Technical Service Bulletin

19 Engine: cooling system - engine overheats, red coolant temperature warning, MIL on - 4.0 ltr. V8 TFSI; P029900

19 24 68 2074303/3 September 23, 2024. Supersedes Technical Service Bulletin Group 19 number 24-62 dated July 3, 2024 for reasons listed below.

Figure 1. Assembly overview – coolant pump/thermostat incl. switchable mechanical coolant pump, number 12.

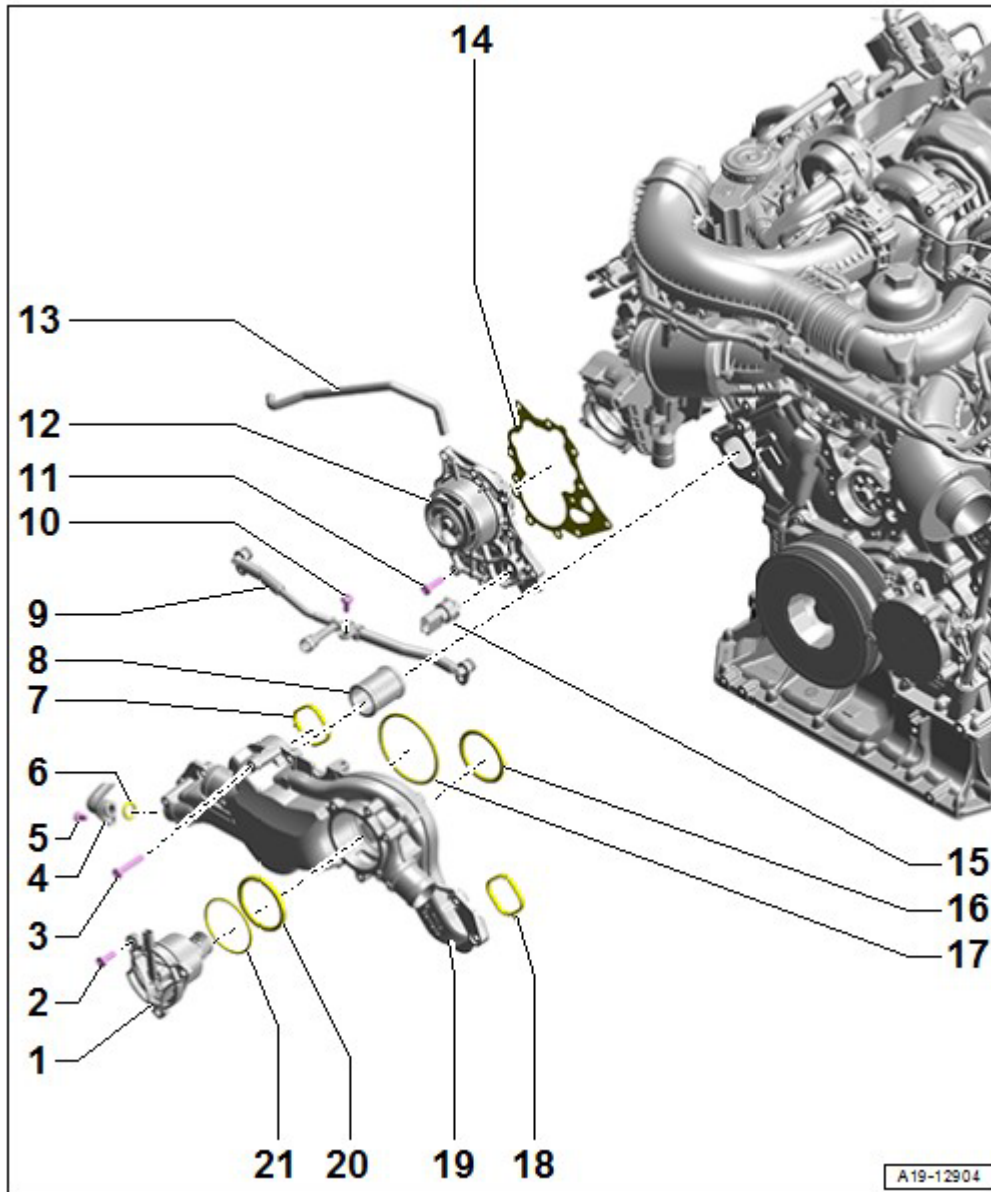
EA825 V8 TFSI engines across all power classes are currently equipped with a switchable mechanical coolant pump.

It is activated via the electric changeover valve N649.

When N649 is activated, it switches a vacuum to the mechanical coolant pump. This pushes a locking sleeve over the pump impeller, which can cause coolant to stagnate.

When N649 is not activated, no vacuum is switched to the mechanical coolant pump, and the coolant pump is not covered. In this case, the coolant is pumped through the coolant pump impeller.

Figure 2. Assembly overview – vacuum system incl. N649, number 9.

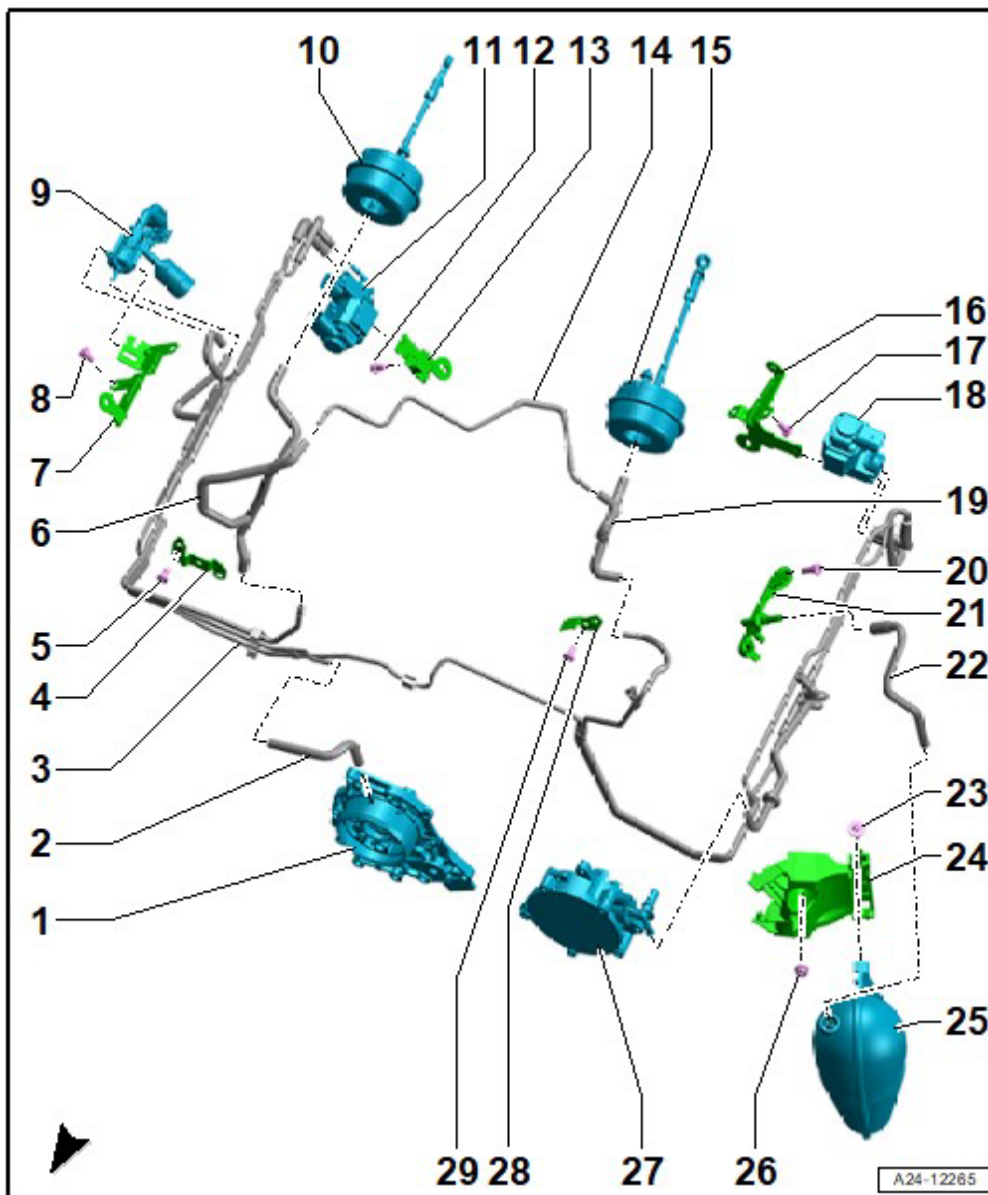
The charge pressure control for the EA825 V8 TFSI turbochargers is electropneumatic.

This means that charge pressure positioners V465 and V546 are electropneumatic pressure converters. Depending on activation (PWM) by the engine control unit, they are able to induce a calculated negative pressure (characteristic curve). This determines the opening path of the wastegate. They are open when they are not activated.
